Groundwater Transfer Review Summary Form

Transfer/PA # T- 13681

Application: T-13681 (Klamath Drought)

Applicant Name: MLM Property LLC

Multi-well hydrograph for area of KLAM0010518

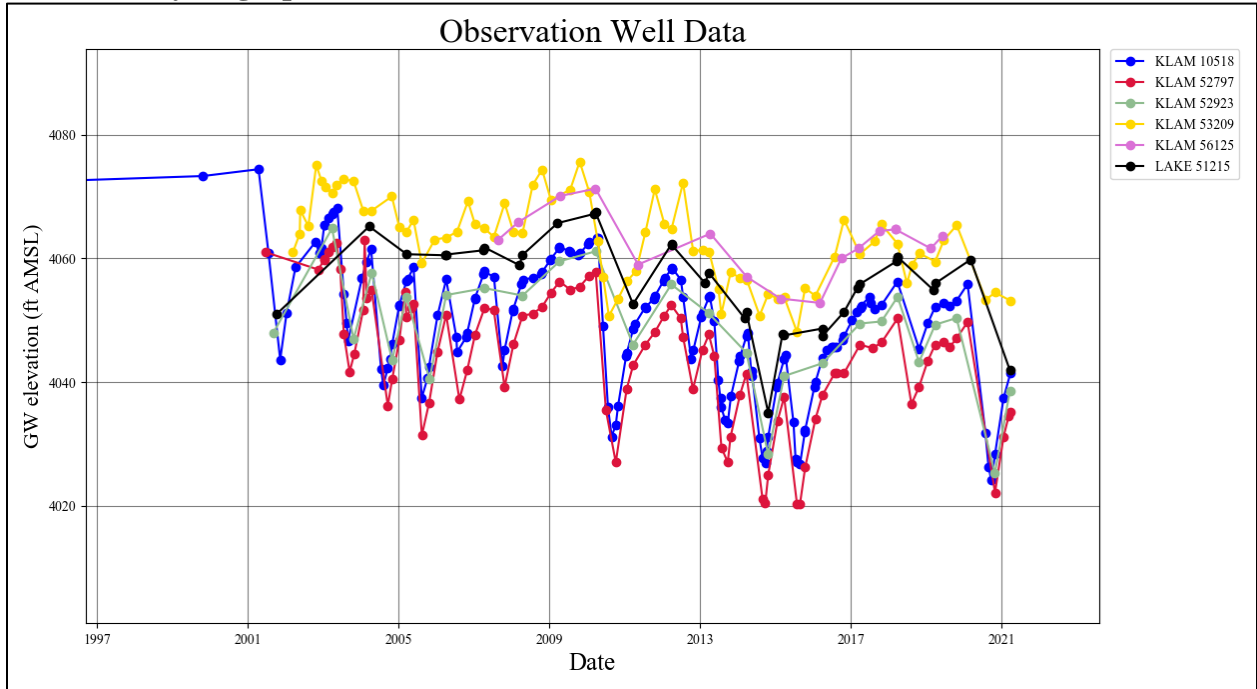
7. What conditions or other changes in the application are necessary to address any potential issues identified above: _____
8. Any additional comments: Water levels in this area have shown persistent declines over the past 20 years with the largest declines exceeding 30 ft in the area of the proposed POA (KLAM0057387). One of the original authorized POAs under Permit G-18390 (KLAM0010518) is located away from the area of the largest declines but still where water level declines have exceeded 20 ft. The proposed transfer would move the full appropriation under this permit closer to the area of the largest declines and concentrate pumping in that area, which will contribute to the long-term declines already observed.
